ADDENDUM NO. 2

VILLAGE OF COVINGTON Wastewater Treatment Plant Improvements Phase II Blower Replacement February 19, 2019

Re: Village of Covington
Wastewater Treatment Plant Improvements Phase II – Blower Replacement

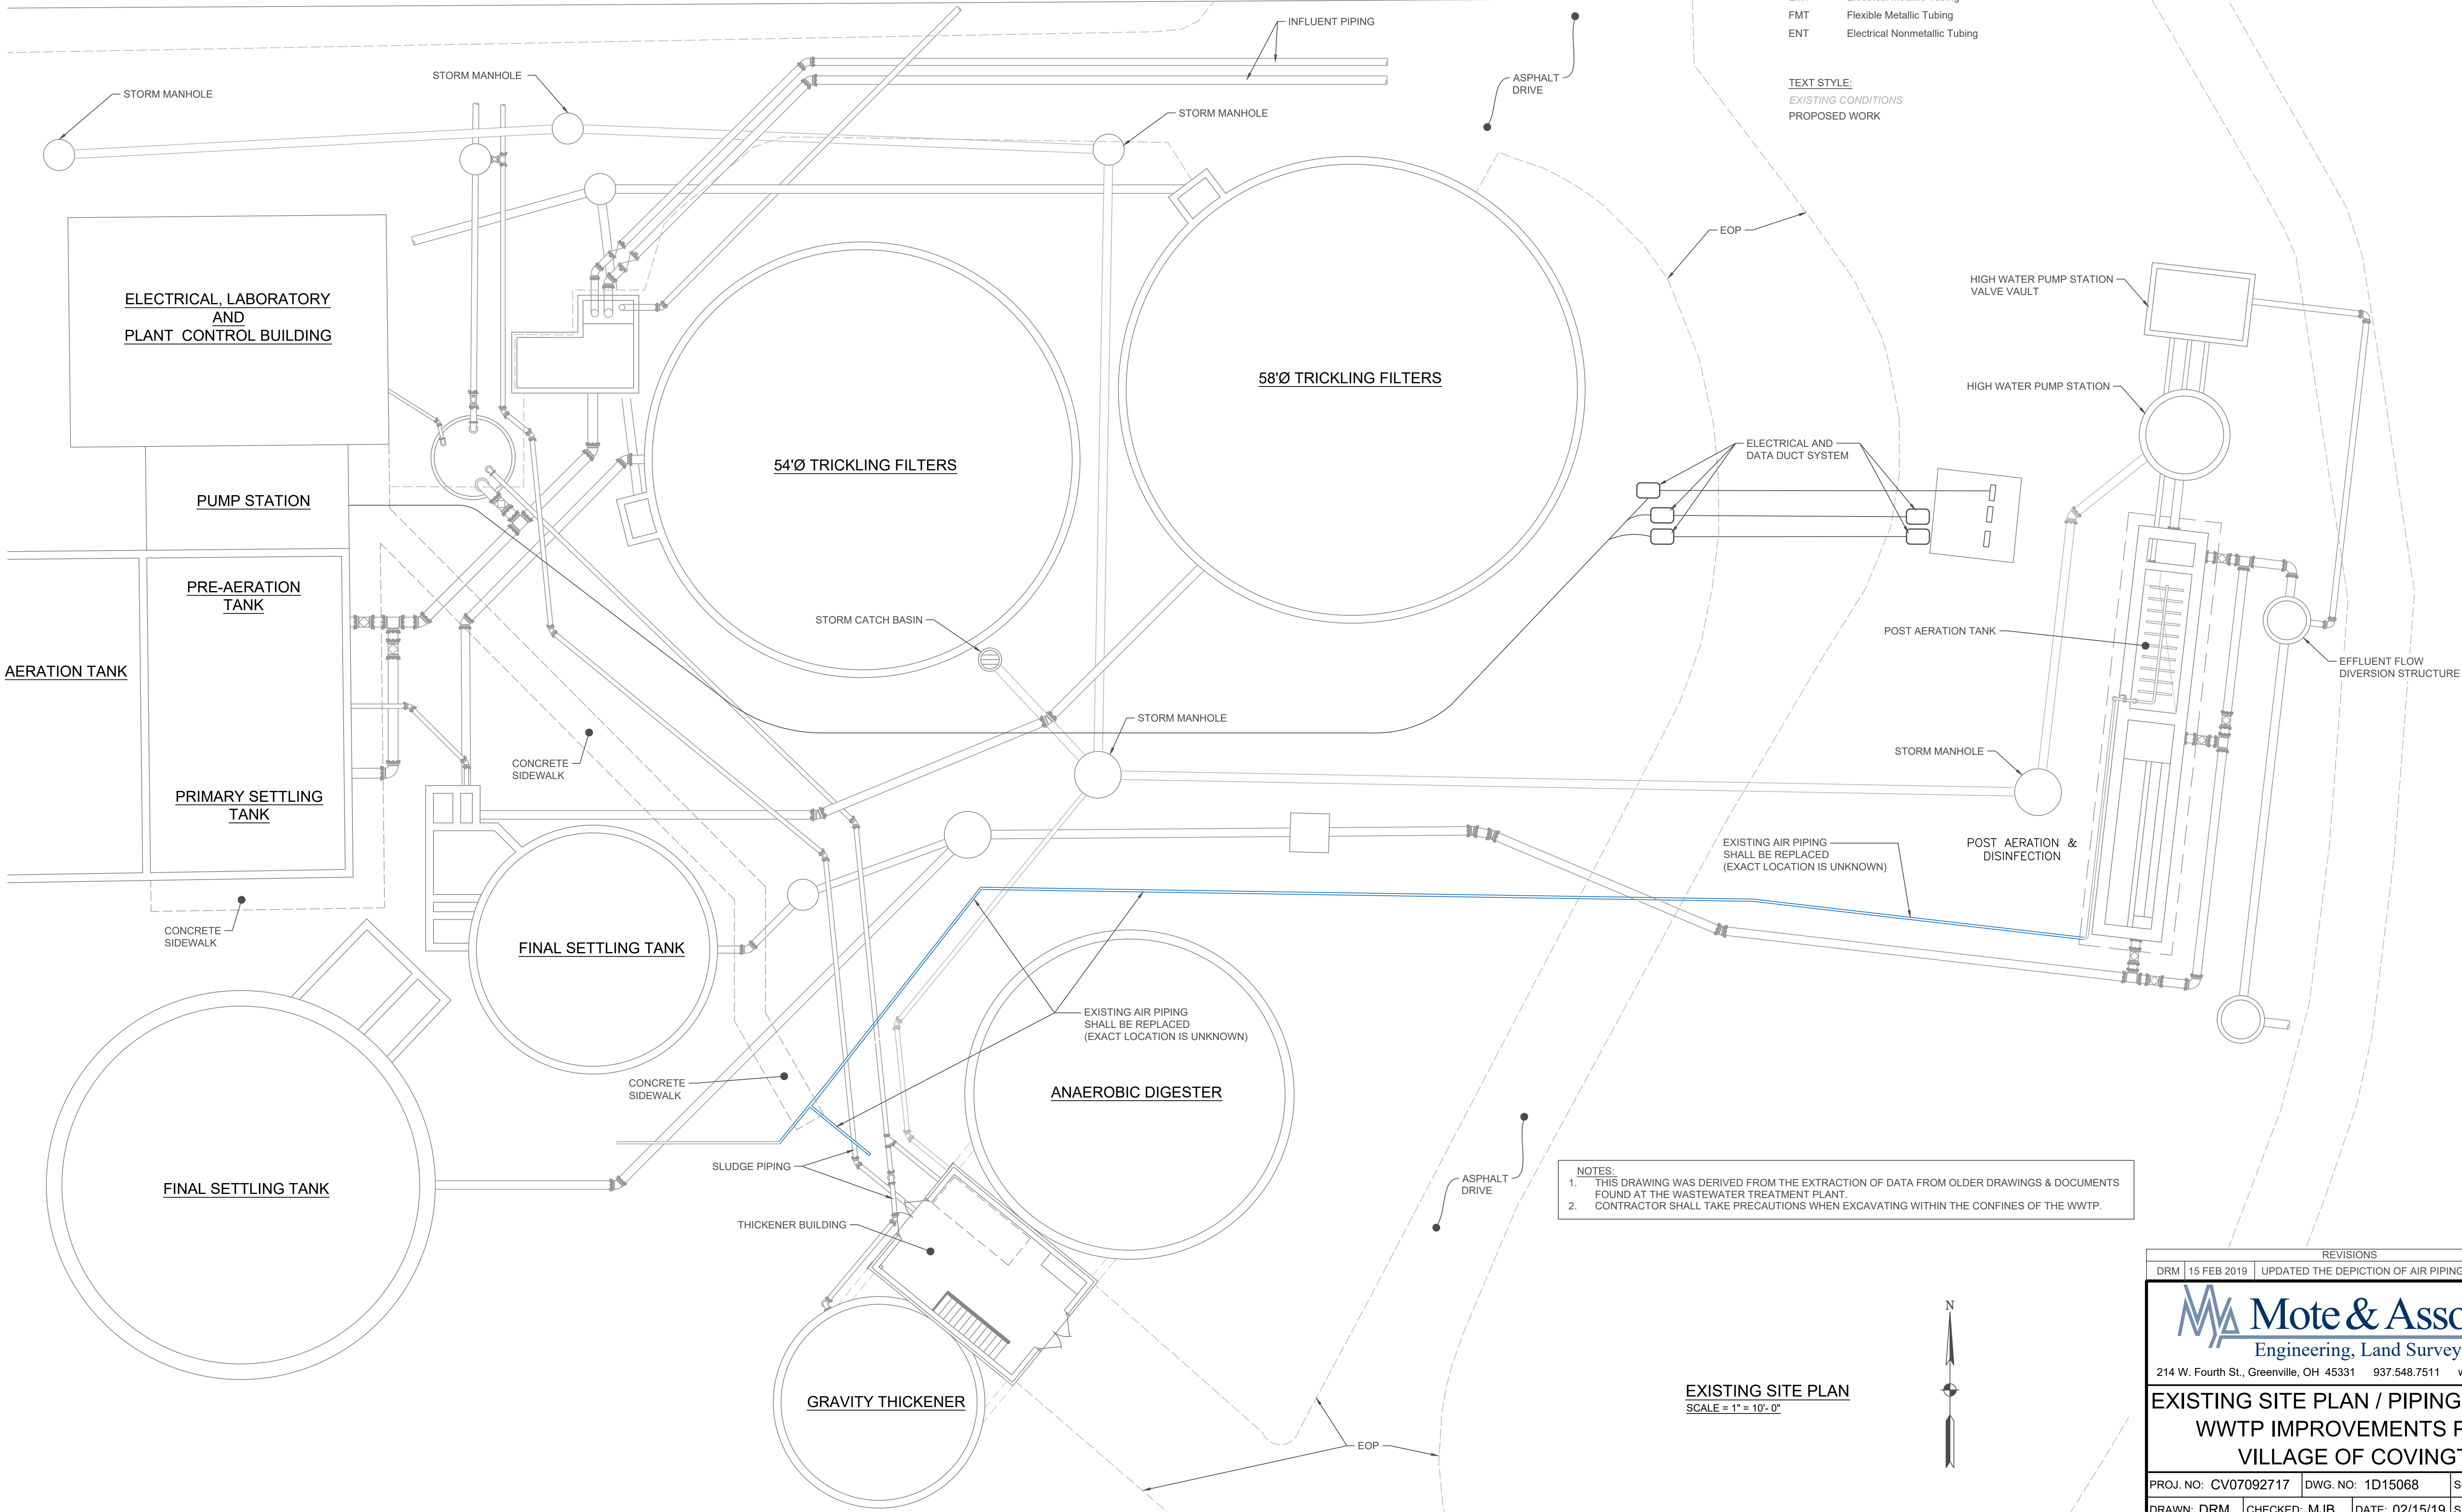
3. Sheet 2A has been updated indicated the amount of air piping to be replaced.
4. Sheets 3A, 4A, 6A, 8A and 9A indicate the changes from fiber-optic to SensorNet Cables.
5. Sheet 5A clarifies the water piping and obsolete equipment to be removed.

REVISIONS			
DRM	15 FEB 2019	UPDATED THE DEPICTION OF AIR PIPING TO BE REPLACED	
 Mote & Associates Engineering, Land Surveying 214 W. Fourth St., Greenville, OH 45331 937.548.7511 www.moteassociates.com			
EXISTING SITE PLAN / PIPING & UTILITIES WWTP IMPROVEMENTS PHASE 2 VILLAGE OF COVINGTON			
PROJ. NO: CV07092717	DWG. NO: 1D15068	SCALE: AS NOTED	
DRAWN: DRM	CHECKED: MJB	DATE: 02/15/19	SHEET NO: 2A OF 9

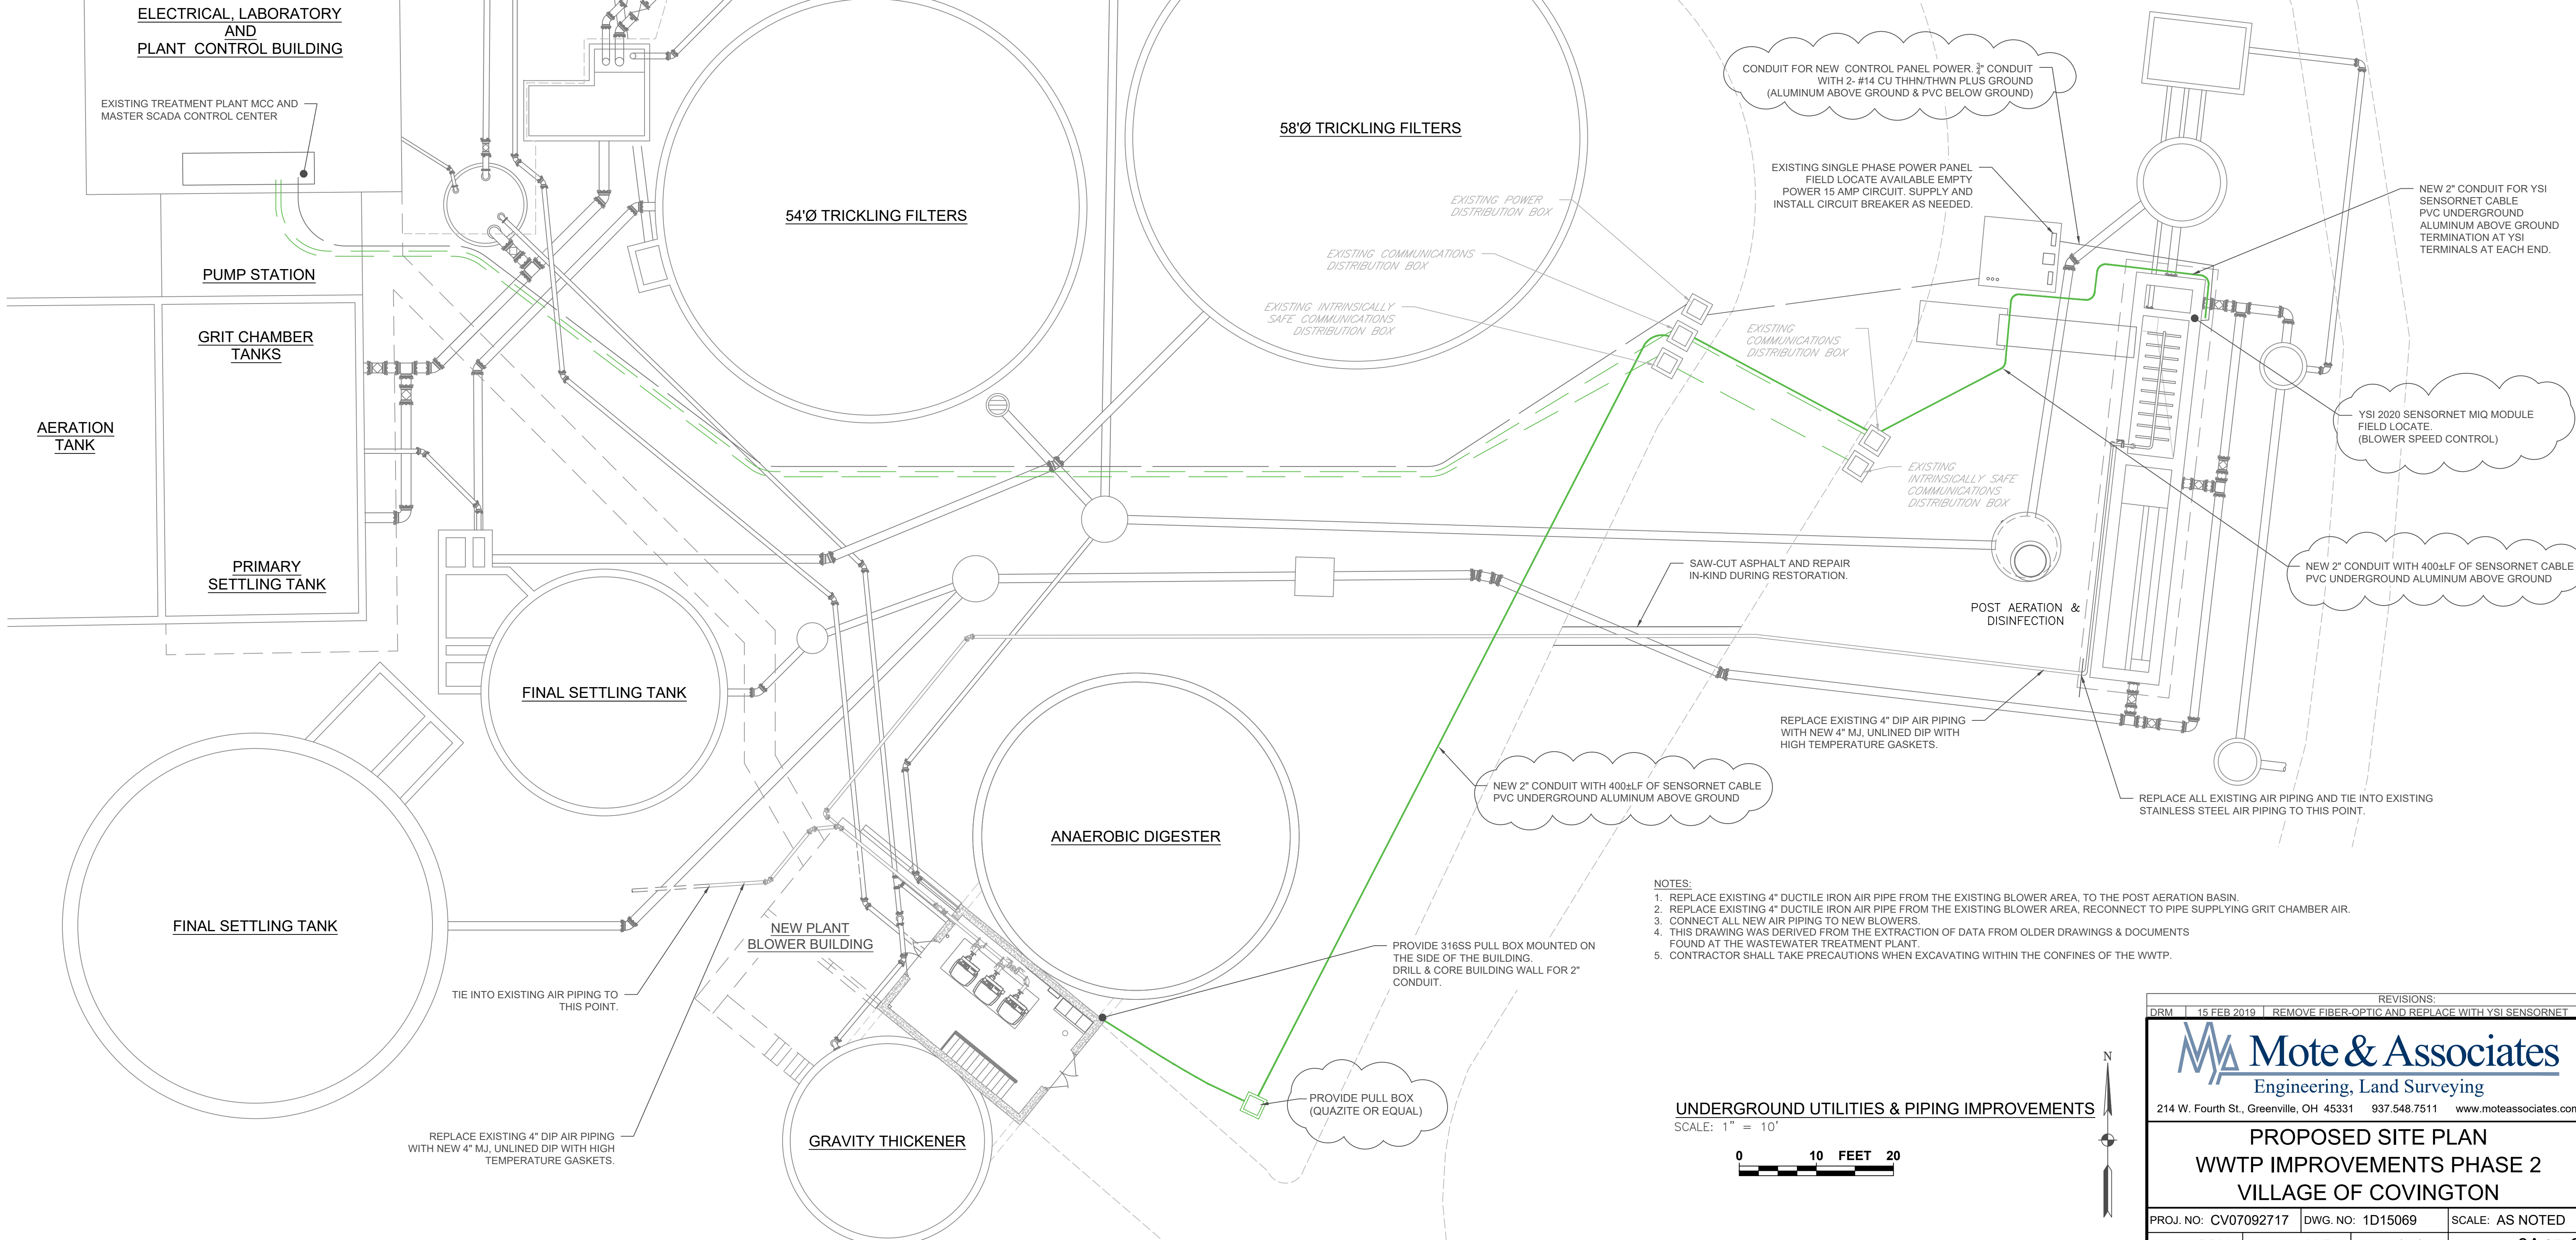
REVISIONS:			
DRM	15 FEB 2019	REMOVE FIBER-OPTIC AND REPLACE WITH YSI SENSORNET	
 Mote & Associates Engineering, Land Surveying 214 W. Fourth St., Greenville, OH 45331 937.548.7511 www.moteassociates.com			
PROPOSED SITE PLAN WWTP IMPROVEMENTS PHASE 2 VILLAGE OF COVINGTON			
PROJ. NO: CV07092717	DWG. NO: 1D15069	SCALE: AS NOTED	
DRAWN: DRM	CHECKED: MJB	DATE: 2/18/19	SHEET NO: 3A OF 9

- NOTES:
1. REPLACE EXISTING 4" DUCTILE IRON AIR PIPE FROM THE EXISTING BLOWER AREA, TO THE POST AERATION BASIN.
 2. REPLACE EXISTING 4" DUCTILE IRON AIR PIPE FROM THE EXISTING BLOWER AREA, RECONNECT TO PIPE SUPPLYING GRIT CHAMBER AIR.
 3. CONNECT ALL NEW AIR PIPING TO NEW BLOWERS.
 4. THIS DRAWING WAS DERIVED FROM THE EXTRACTION OF DATA FROM OLDER DRAWINGS & DOCUMENTS FOUND AT THE WASTEWATER TREATMENT PLANT.
 5. CONTRACTOR SHALL TAKE PRECAUTIONS WHEN EXCAVATING WITHIN THE CONFINES OF THE WWTP.
